PIKE ■ McFARLAND ■ HALL
ASSOCIATES, INC.
ARCHITECTS AND PLANNERS

ADDENDUM NO. 3

**ALTERATIONS & ADDITIONS TO:
POLICE ANNEX TRAINING CENTER
MARKET COMMON**

Myrtle Beach, South Carolina
January 10, 2020

1 EXT DOOR #28 TO K9 - ADD #3
B3 SCALE: 1/8"=1'-0"

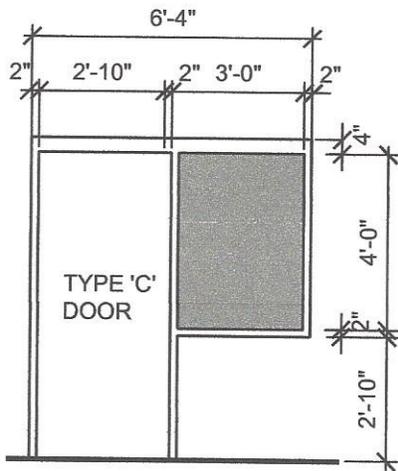
- A4. *Door #28 is to be a hollow metal door with lite (type C) and hollow metal frame (Ha). Contractor to refer to Bulletin Drawing B3 attached for elevation of new frame.*

1. SHEET A1.0
 - A. Contractor's attention is directed Door #28. Contractor is advised this door is to be a hollow metal door with lite (Type C) and hollow metal frame (Ha) per Bulletin Drawing B3 (attached herewith) consisting of 1 page dated 01/08/2020 for elevation of new frame.

HM DOOR W/ LITE AND HM FRAME-
SEE ELEVATION 2/B3 BELOW

2 EXT DOOR FRAME TO K9 -
ELEVATION
B3 SCALE: 1/4"=1'-0"

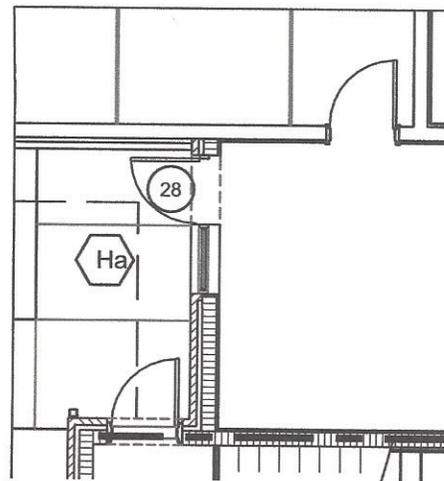
- A10. *Door #28 is to be a hollow metal door with lite (type C) and hollow metal frame (Ha). Contractor to refer to Bulletin Drawing B3 attached for elevation of new frame.*

- Q15. IS DOOR “28” TO BE ALUM OR HM? DOOR SCHEDULE SAYS HM BUT ELEVATION SAYS ALUM STOREFRONT?**
- A15. *Door #28 is to be a hollow metal door with lite (type C) and hollow metal frame (Ha). Contractor to refer to Bulletin Drawing B3 attached for elevation of new frame.*

WINDOW - EXTERIOR
HOLLOW METAL FRAME W/
HIGH IMPACT GLAZING
